THREE MILE HILL GOLD PROJECT NEAR COOLGARDIE

GOLDFAN LTD

Report and Recommendations of the  
Environmental Protection Authority

Bulletin 394, July 1989

Figure 1. Mine Location and Site Layout (from NOI Goldfan Ltd)

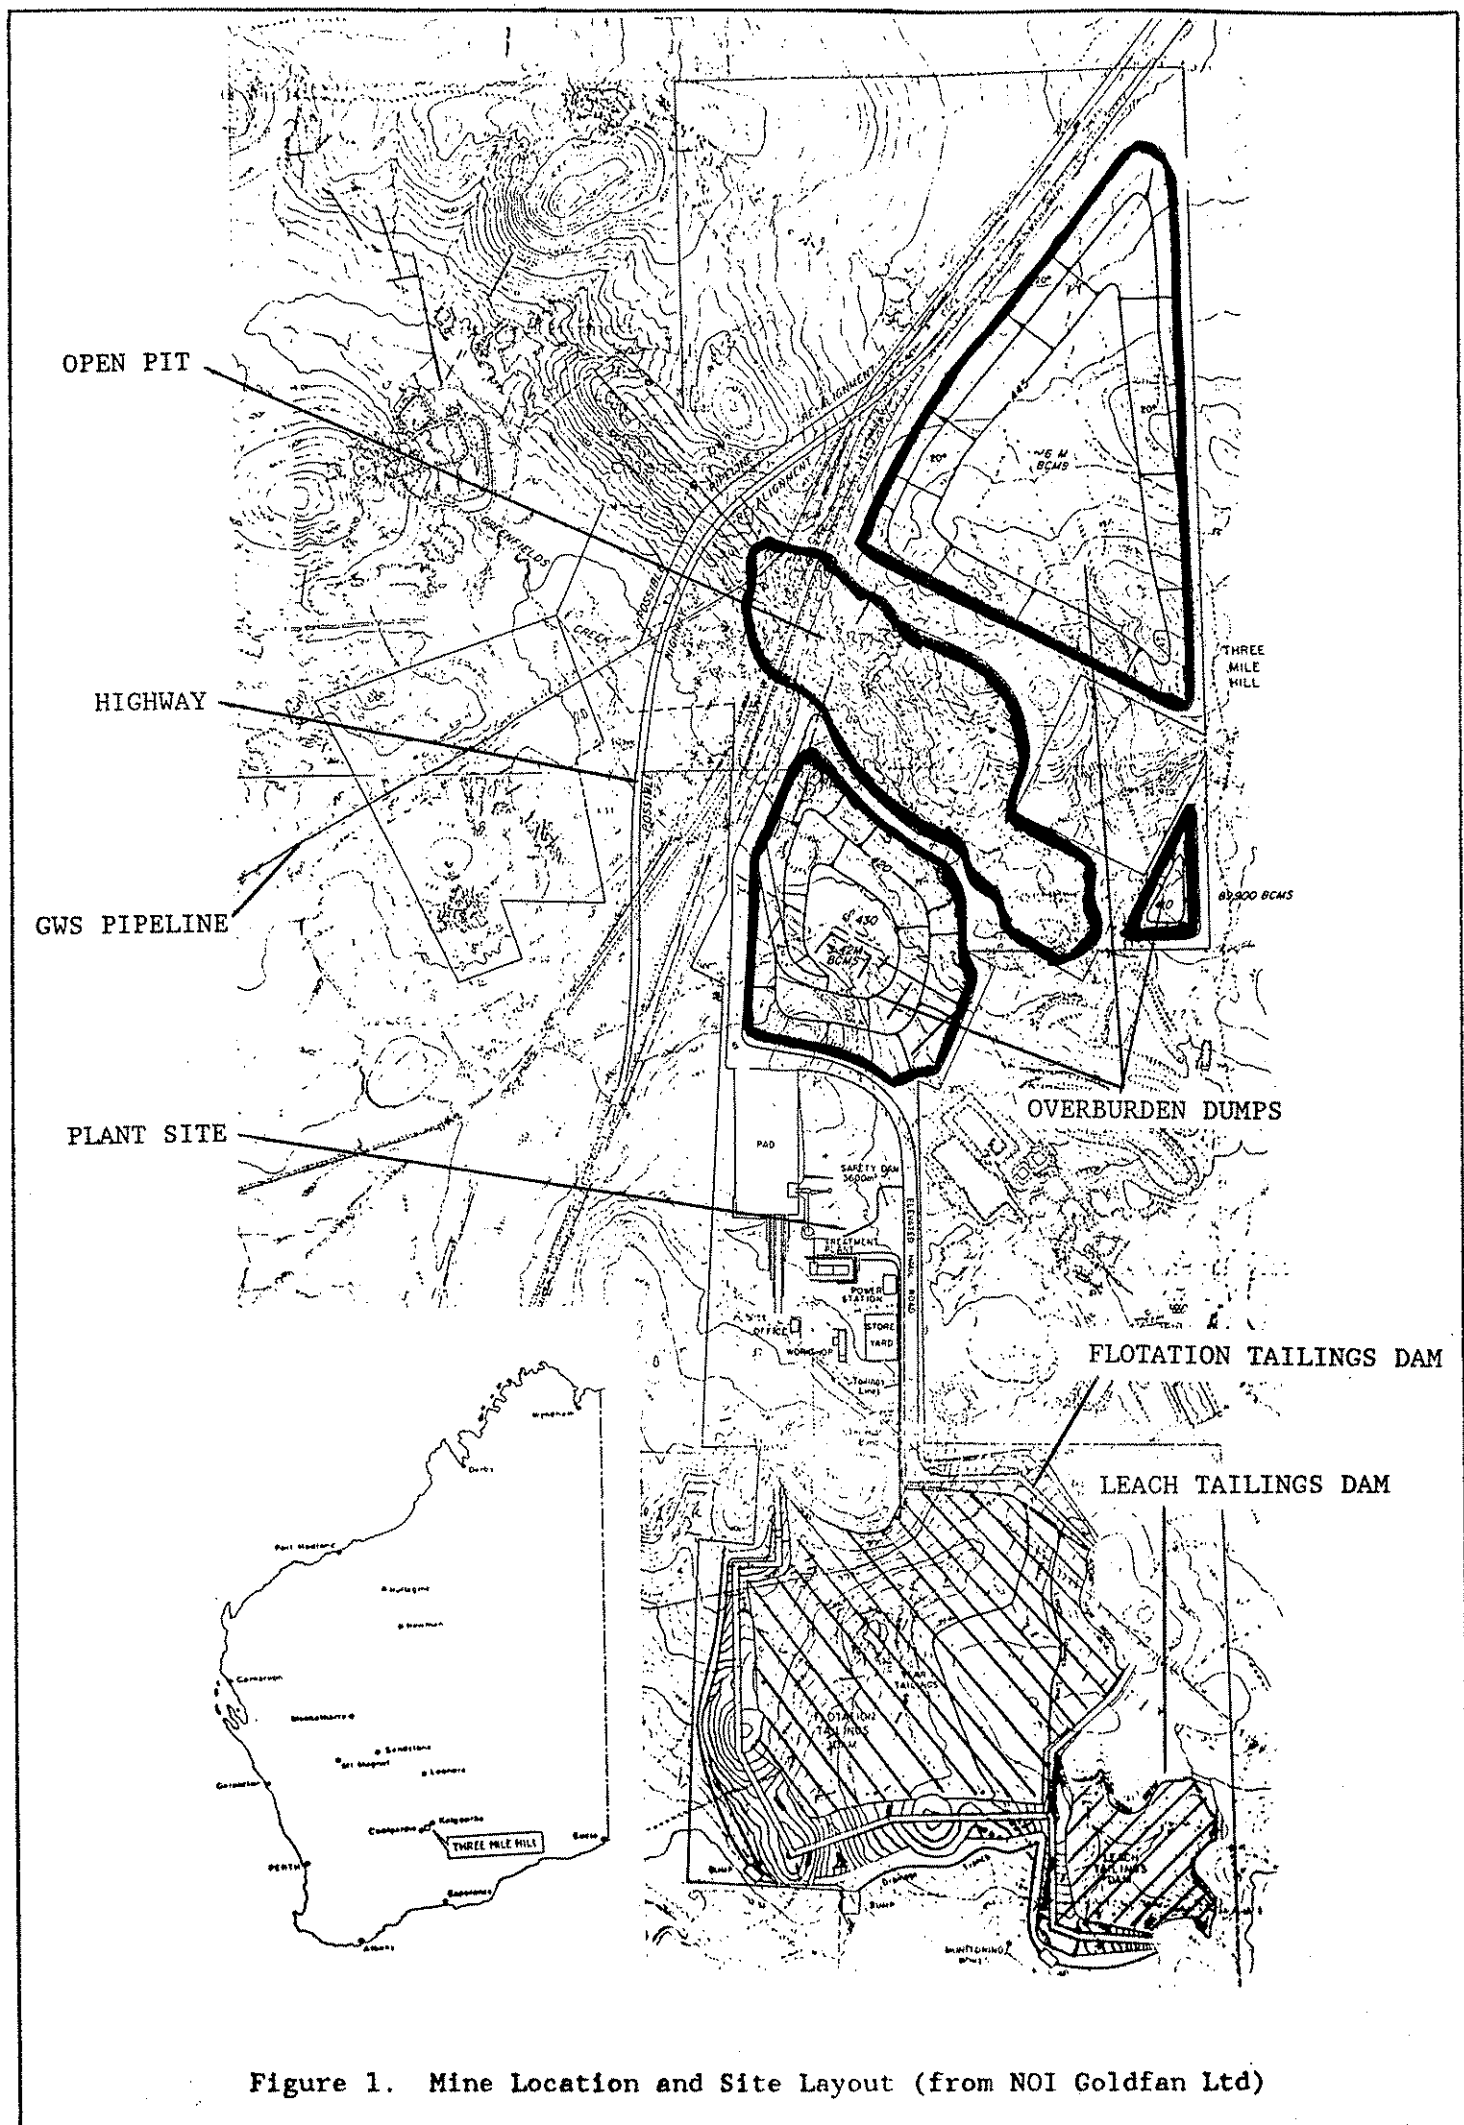
Goldfan Ltd proposes to mine gold from an open cut mine at Three Mile Hill, approximately 5 km northeast of Coolgardie, adjacent to the Great Eastern Highway. Mining will be in three stages down to a maximum pit depth of 170 m (Figure 1).

The proposal requires realigning a 1200 m section of the Great Eastern Highway and a shorter section of the Goldfields Water Supply pipeline to divert them around the open pit.

The proponent intends to locate the initial topsoil dumps near the Great Eastern Highway as a visual buffer, but it is possible that during severe easterly wind events, dust blowing from these bunds may be a road hazard. Thus it is suggested that the topsoil be located elsewhere and temporarily rehabilitated. A bund of overburden covered with a layer of topsoil to encourage revegetation should be used instead.

The waste dumps will consist of a vertical rise of 5 m at a 30 degree face angle and then a 4 m wide berm, resulting in an overall slope of 20 degrees. The face angles are 10 degrees steeper than Mines Department guidelines suggest, but this is due to the lack of space for overburden stockpiling adjacent to the mine. The proponent should investigate the potential for additional stockpiles to be located further away from the open pit to lessen the face angles and thus improve the conditions for rehabilitation.

The Environmental Protection Authority recommends that the proponent undertake dust control in consultation with the Shire of Coolgardie to the satisfaction of the Environmental Protection Authority, to ensure that traffic on the Great Eastern Highway is not adversely affected by dust from the minesite.

The Environmental Protection Authority recommends that the proponent investigate the potential for locating additional overburden stockpiles at a greater distance from the pit, thus decreasing the face angles and improving the conditions for rehabilitation, and that this be reported to the Authority prior to the commencement of stockpiling.
